APPLICATION NUMBER: 18/00378/AR

ADDRESS: Northgate House, Upper Borough Walls

PROPOSAL: Display of 1. non-illuminated letters sign above the entrance to

COMMENT: OBJECTION

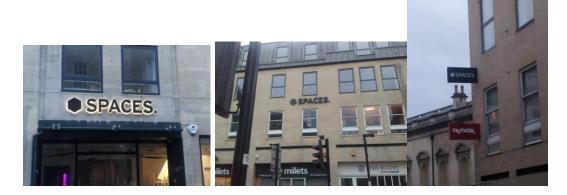
We first have to address the issue of the unauthorised works. The applicants/agent would already be aware of the inappropriate and unsympathetic nature of the proposals from the previously submitted application and the objections therein. It is therefore extremely disappointing to find that despite this the signage has already been installed.

However, as shown above the signs have already been installed and therefore their unsuitability is there for all to see.

The use of stainless steel is more appropriate. However we do not support the use of black due to its starkness. A natural brushed silver surface would be more acceptable.

As shown above the illumination has been installed and should be removed.
